Memorandum

To: Planning Commission Members
From: Elizabeth J Corwin, PE, AIPC; Planning Director
Date: July 11, 2024
Re: School Bell Child Care Center Expansion
4501 W Highland
PIN 11-30-101-002
URSA 24-03/SPR 24-04

Special Land Use Review For Highland Township, Michigan

Applicant:	School in the Pines Inc. and Marc Kasabasic
Project Name:	School Bell Child Care
Plan Date:	May 31, 2024
Location:	4501 West Highland Road Parcel #11-30-101-002 East of Highland Road and South Tipsico Lake Road Intersection
Zoning:	Lakes and Villages (LV)
Action Requested:	Special Land Use Preliminary Site Plan Approval

SITE PLAN

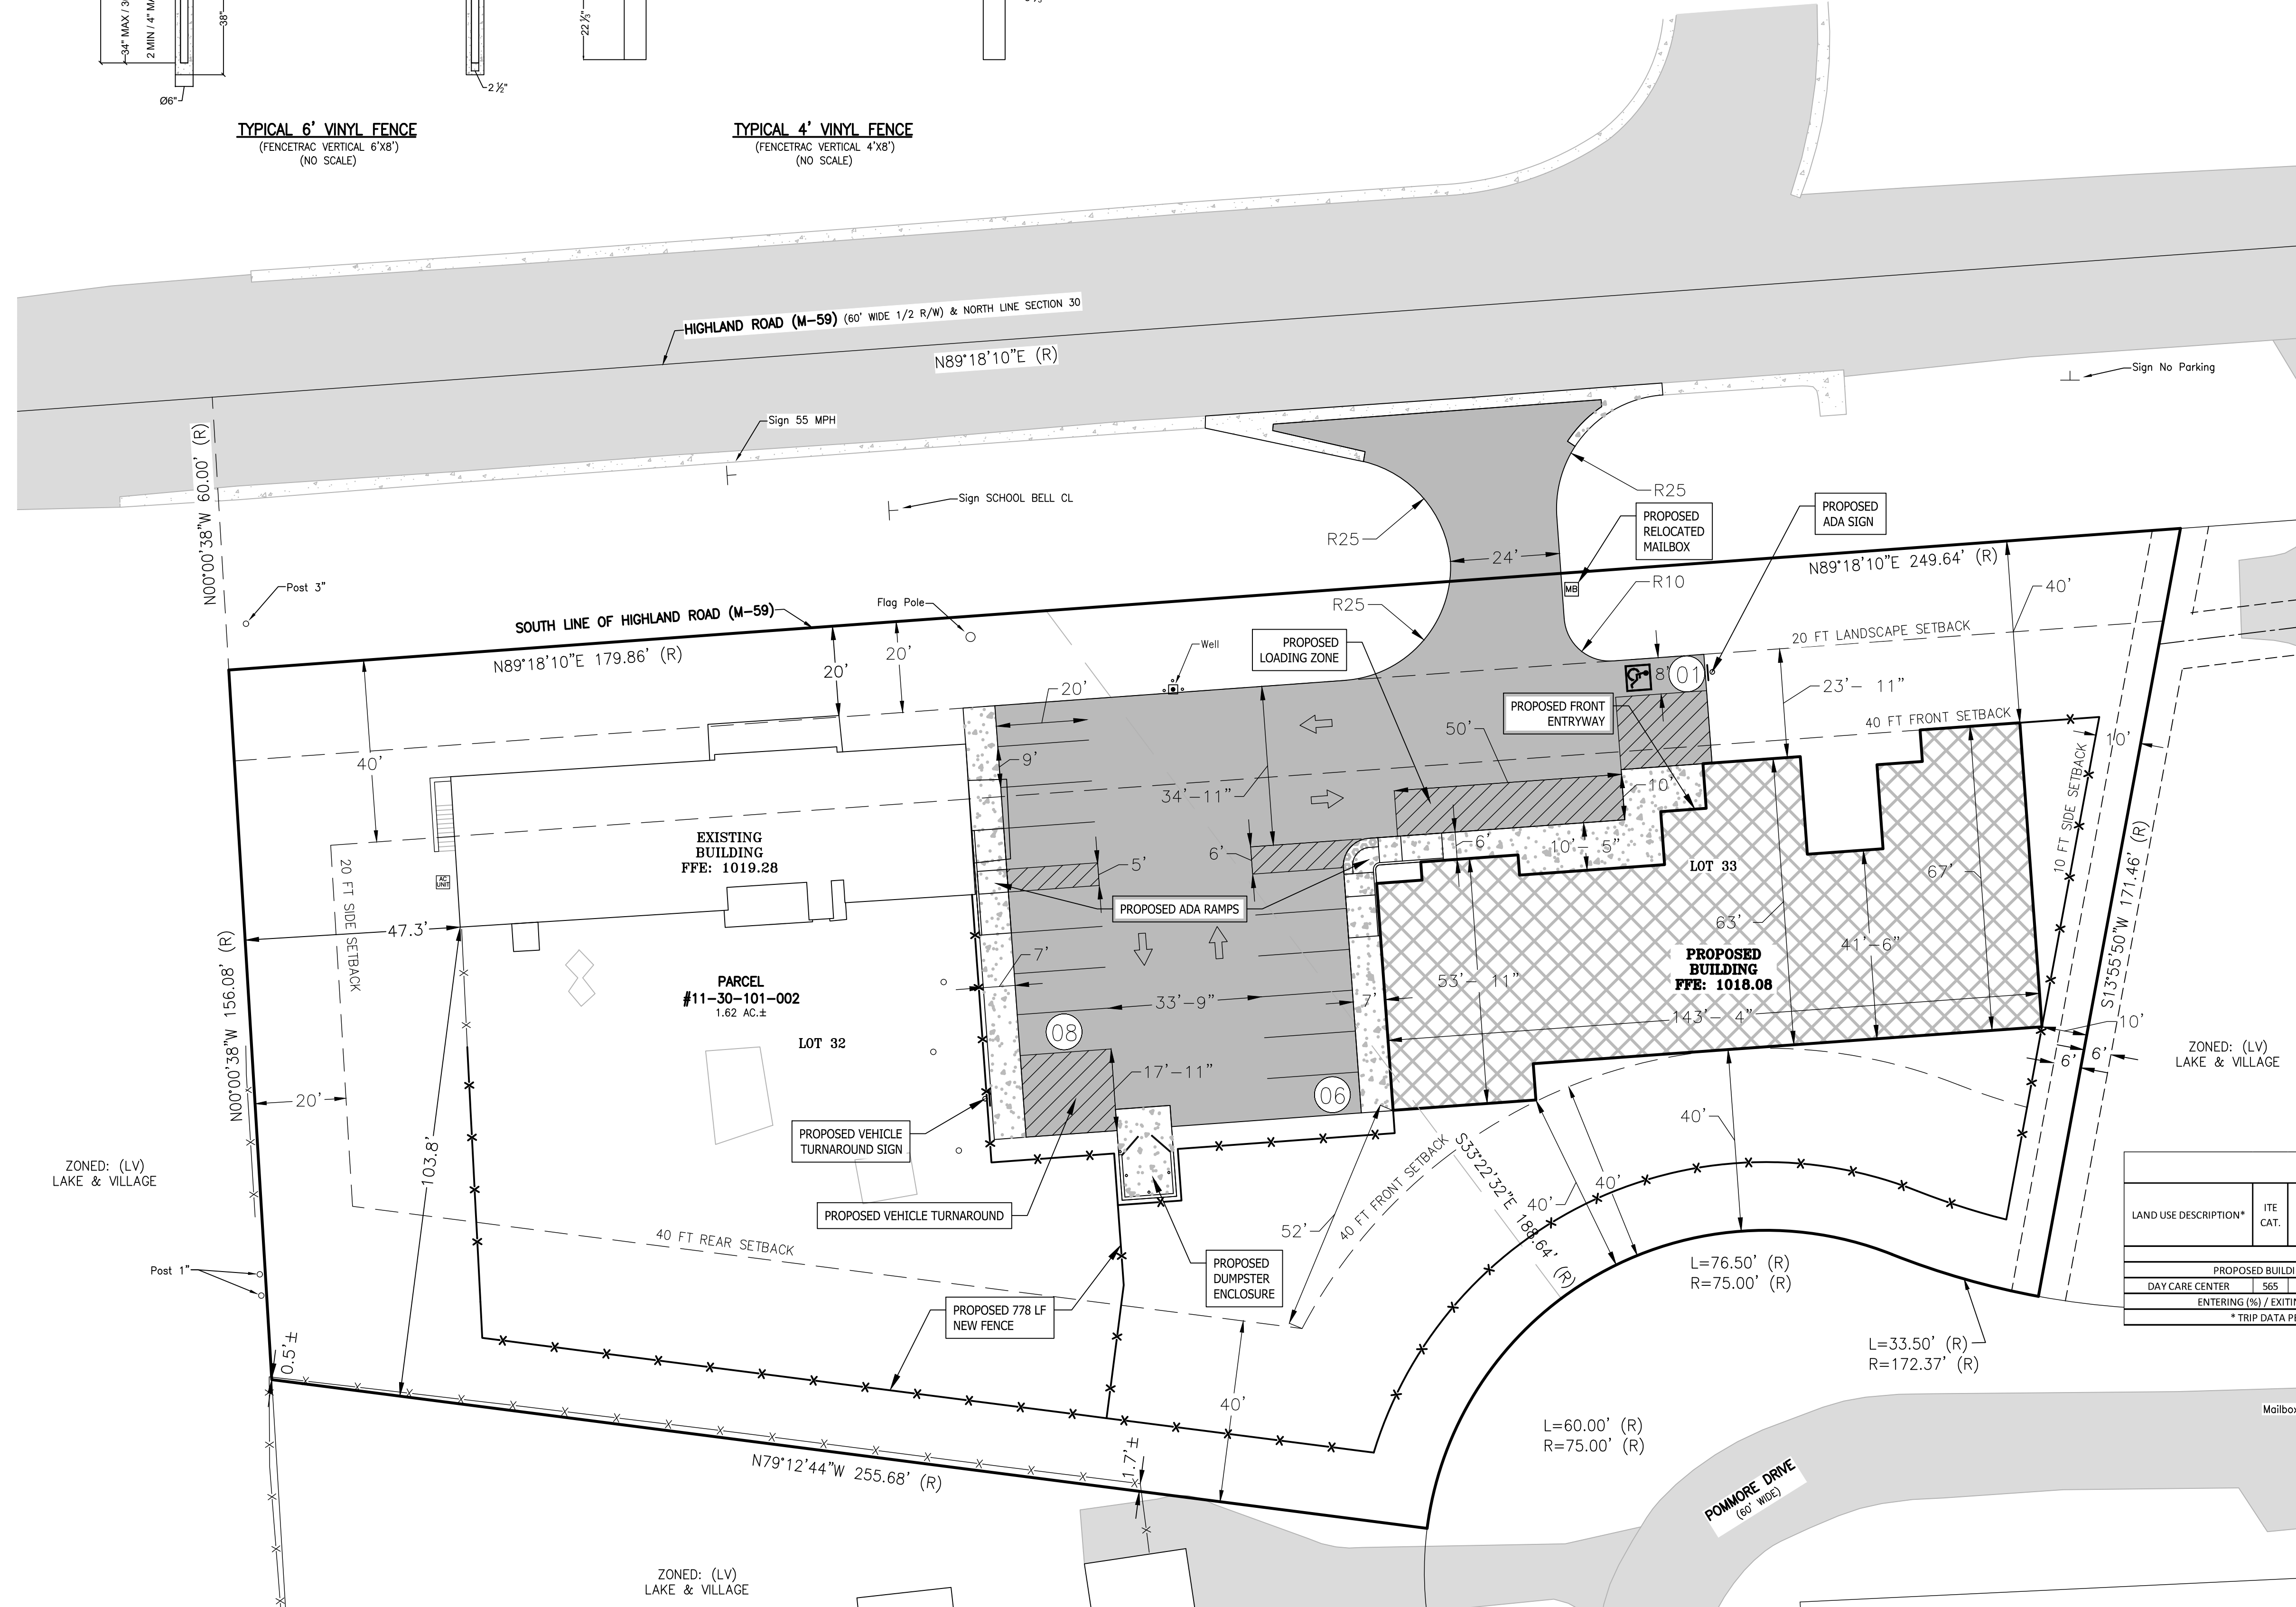
The applicant is proposing 778 lineal feet of vinyl fencing at heights of four (4) feet and six (6) feet along the rear perimeter. The plans do not delineate where the fence is proposed to be four (4) feet or six (6) feet.

Items to be Addressed: 1) Applicant to show where fence is proposed to be four (4) feet and where fence is to be six (6) feet. 2) Planning Commission input on screening requirements per Section 12.04.

SHEET NO. 9

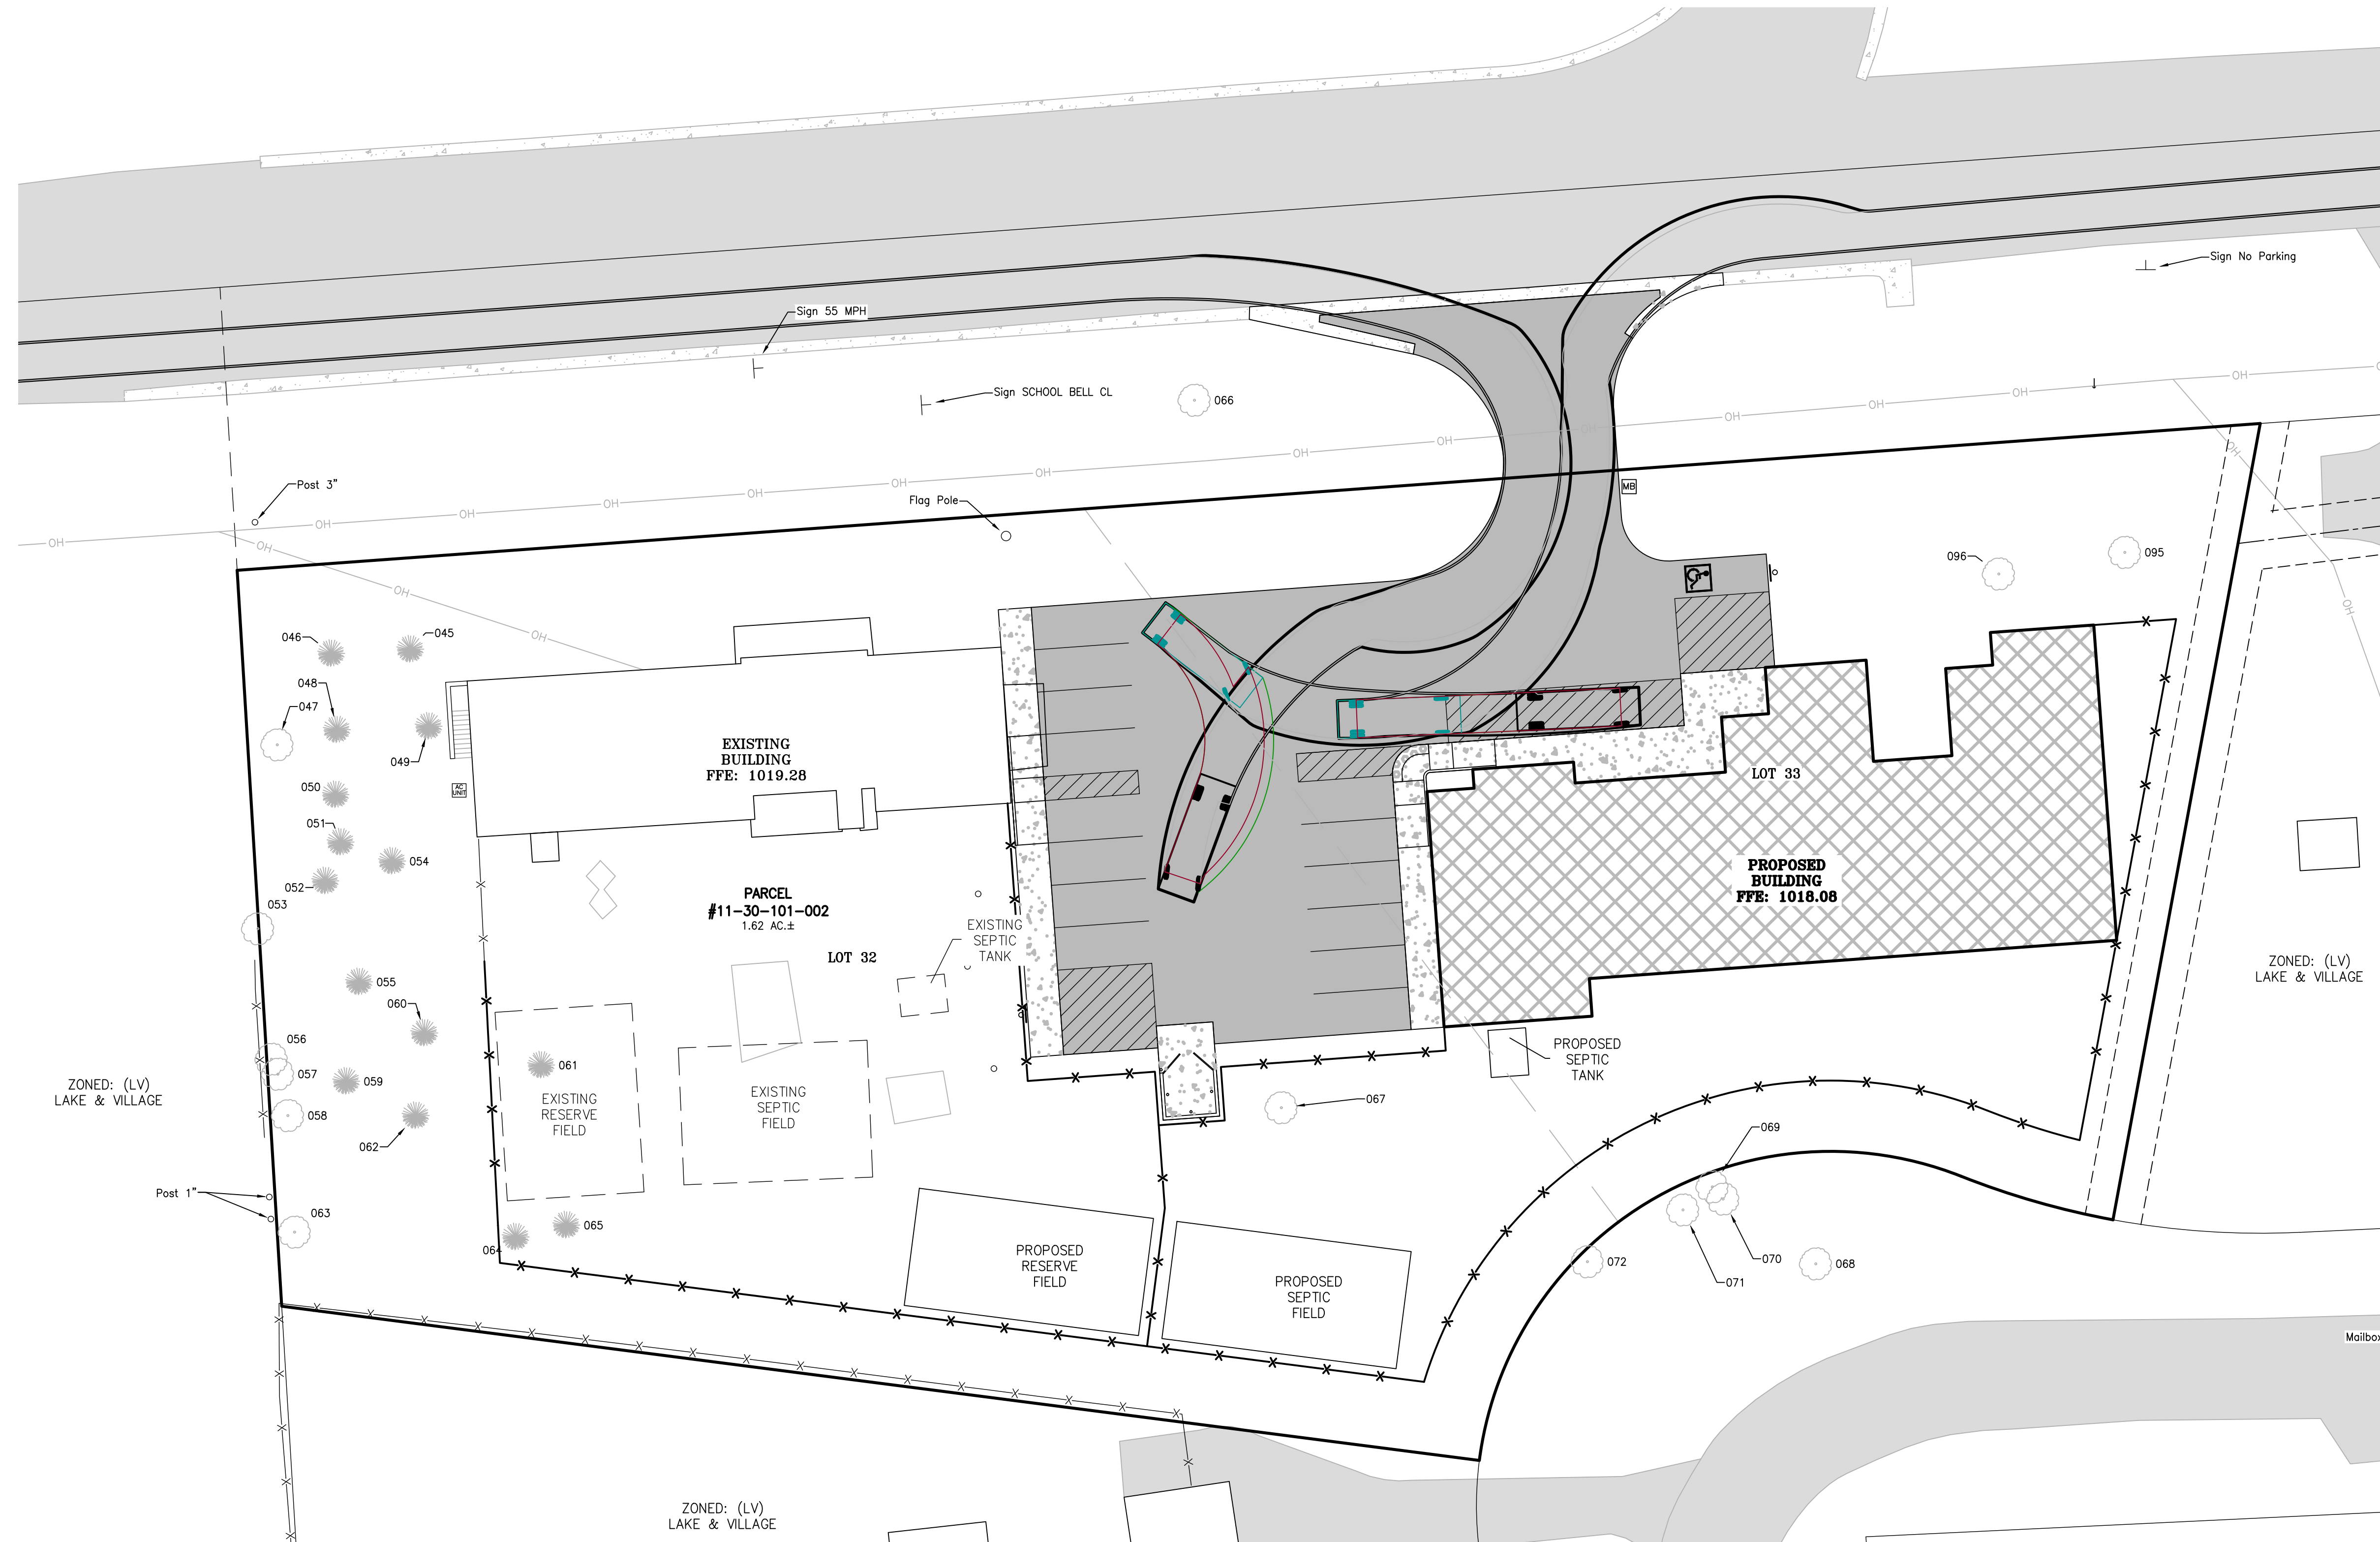
The applicant provides an emergency vehicle circulation plan on Sheet 9, which demonstrates proper vehicular traffic flow.

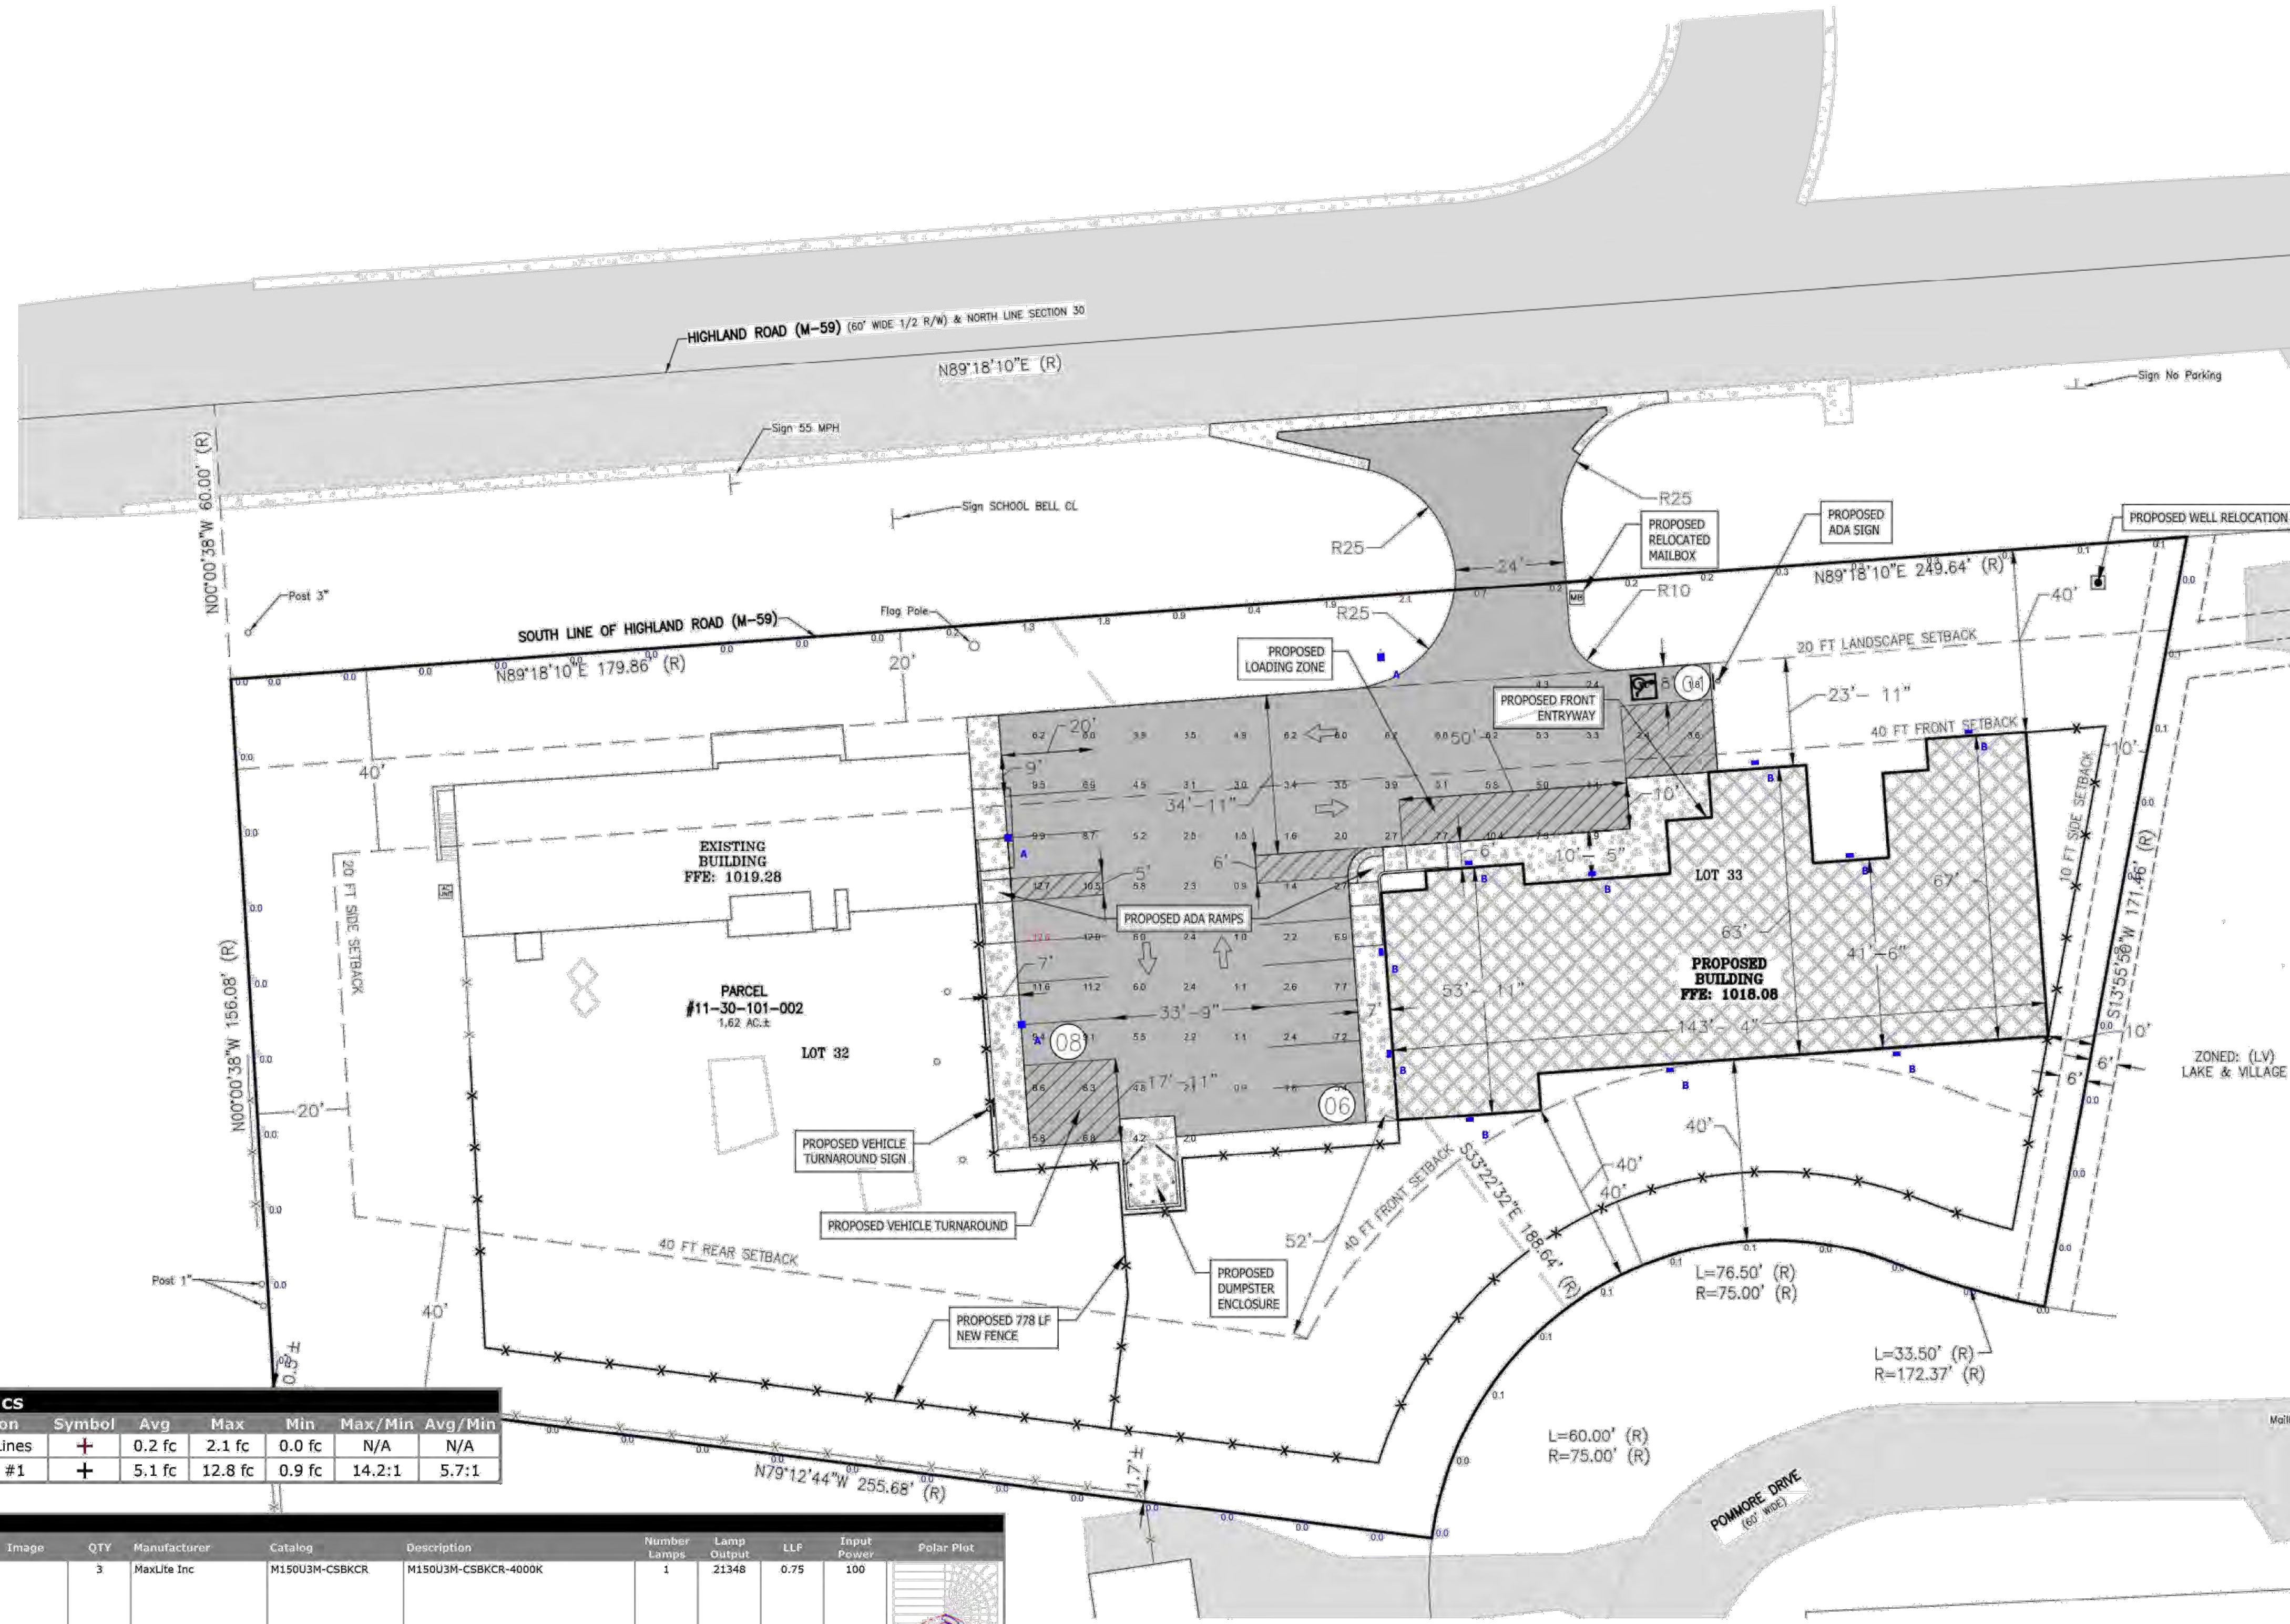
A sufficient lighting plan has been provided on Sheet E-04. A photometric plan indicates that the light levels at property lines are acceptable. Planned lighting is indicated to be included on Sheet E-01, which is not included.

Items to be Addressed: Include Sheet E-01 for fixture locations, specifications, and other lighting system information.
